CITY PLAN COMMISSION**THURSDAY, MARCH 21, 2024****FILE NUMBER:** S234-065**SENIOR PLANNER:** Sharmila Shrestha**LOCATION:** Bruton Road, east of Prairie Creek Road**DATE FILED:** February 21, 2024**ZONING:** CR**CITY COUNCIL DISTRICT:** 5**SIZE OF REQUEST:** 0.72-acre**APPLICANT/OWNER:** Walia and Sons Real Estate, Inc.

REQUEST: An application to replat a 0.72-acre tract of land containing all of Lots 15 and 16 in City Block 10/6315 to create one lot on property located on Bruton Road, east of Prairie Creek Road.

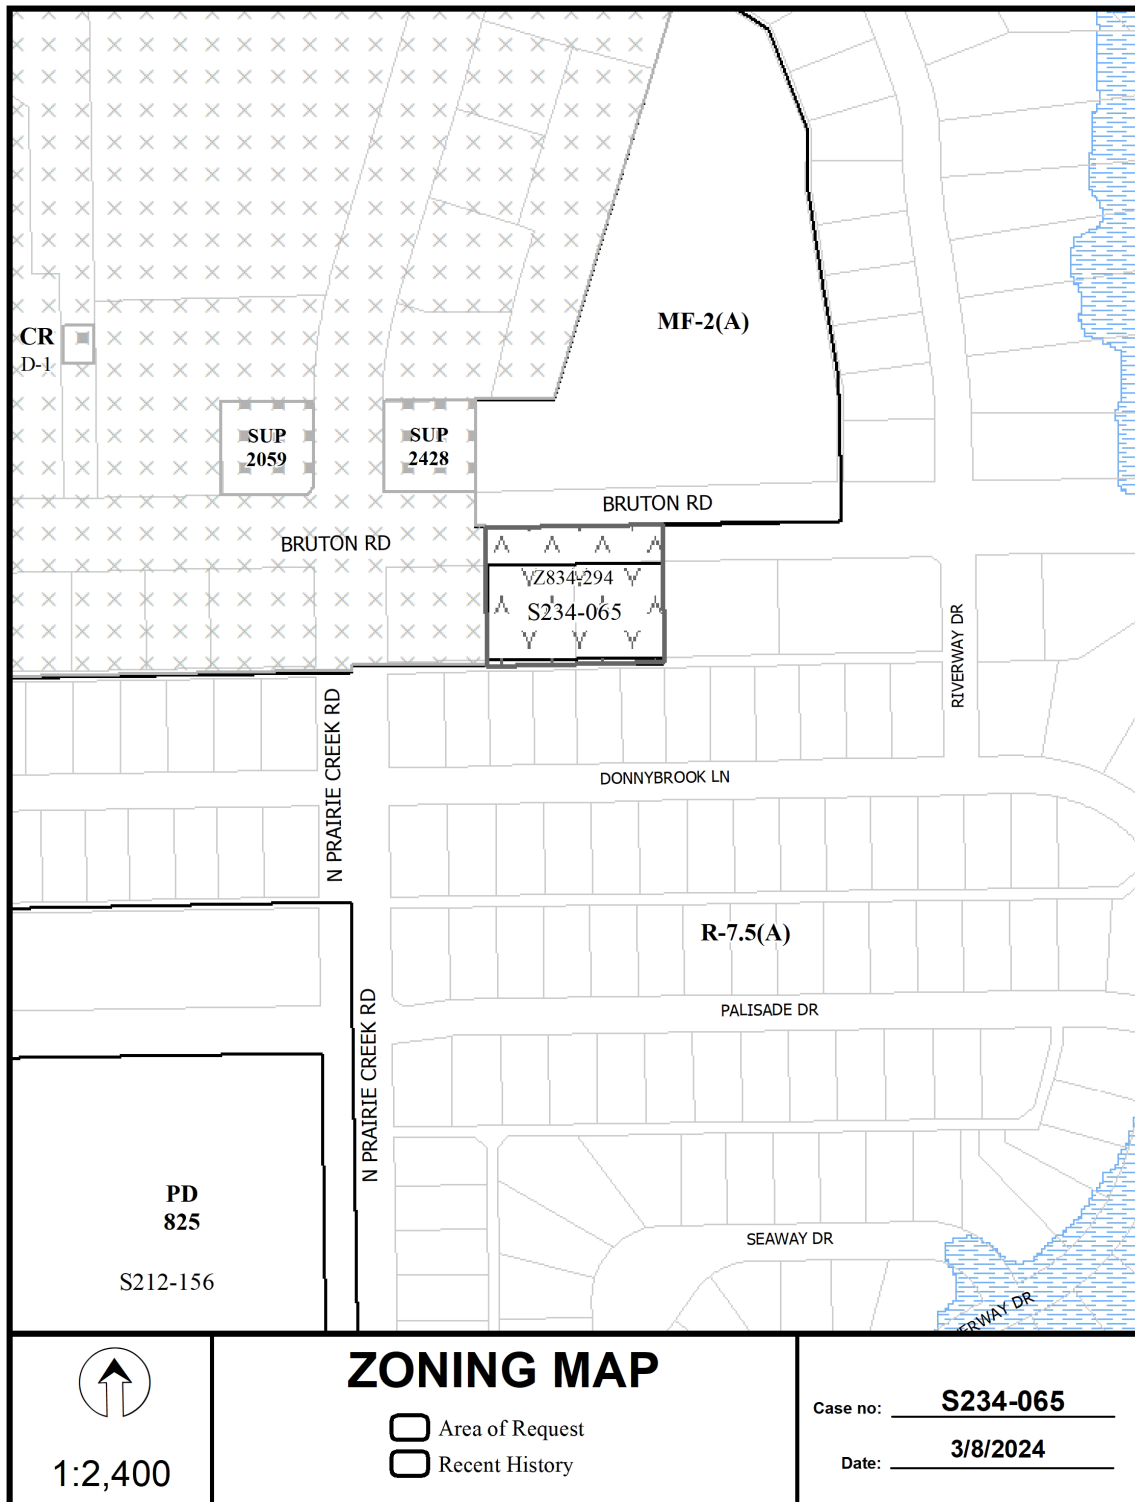
15. Prior to final plat, submit a completed final plat checklist and all supporting documents.
16. On the final plat, show the correct recording information for the subject property.
17. On the final plat, show recording information on all existing easements within 150 feet of the property.
18. On the final plat, show all additions or tracts of land within 150 feet of the property with recording information.

22. On the final plat, change “N Prairie Creek Road (FKA Eastfield Blulevard)” to “Prairie Creek Road (FKA Eastfield Boulevard)”.
23. On the final plat, identify the property as Lot 15A in City Block 10/6315.
